Appendix T

Comment Letters on the 2014 Draft EIS/EIR

Subject: Draft Environmental Impact Statement for the Long Term Water Transfers Project,
Various Counties, California (CEQ# 20140290)

California Department of Water Resources

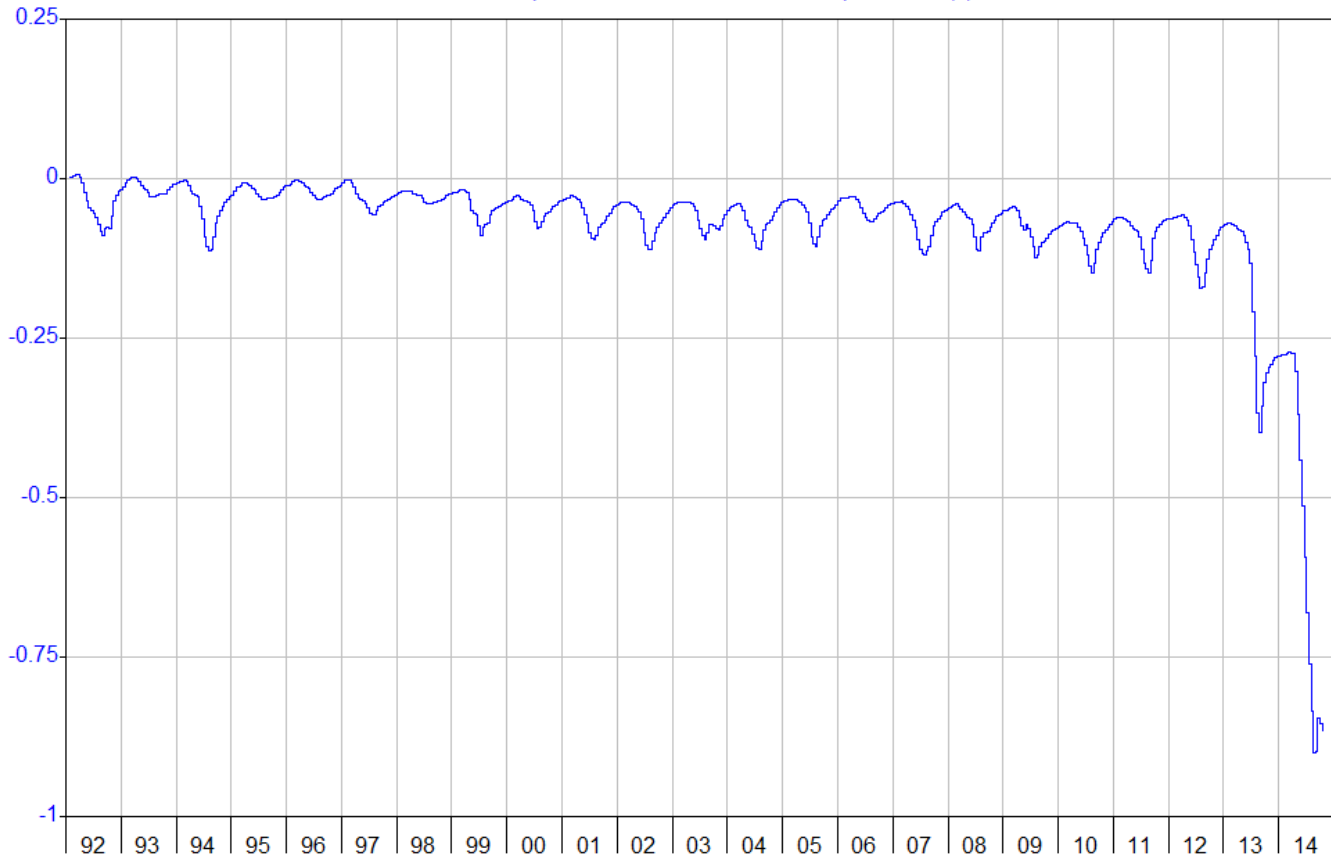
- b. Measuring groundwater level drawdown at only one location on Conaway Ranch is inadequate given the magnitude of Conaway's proposed groundwater substitutions. (Draft EIS/EIR, at Figure 3.3-26.) As the EIS/EIR indicates, land subsidence has occurred at Conaway Ranch in the past. (Draft EIS/EIR, at 3.3-82.) Accordingly, the EIS/EIR should have analyzed more fully the land subsidence and groundwater level drawdown impacts in Conaway's area. Instead, the EIS/EIR analyzes impacts on groundwater levels and subsidence in three locations far from Conaway, while relegating a hydrograph of the Conaway location (Location 30) to the Appendix with little analysis. (Draft EIS/EIR, at E-204-E210.) Moreover, as Exhibit 1 to this letter demonstrates, the effects of Conaway's groundwater pumping are already causing land subsidence. But instead of measuring conditions that have already occurred, the draft EIS/EIR relies on a simulation of Conaway's proposed pumping that does not take its current actions into account. Therefore, the final EIS/EIR should evaluate potential environmental impacts based on current conditions, rather than on a simulation in which the data set ends in Water Year 2003.
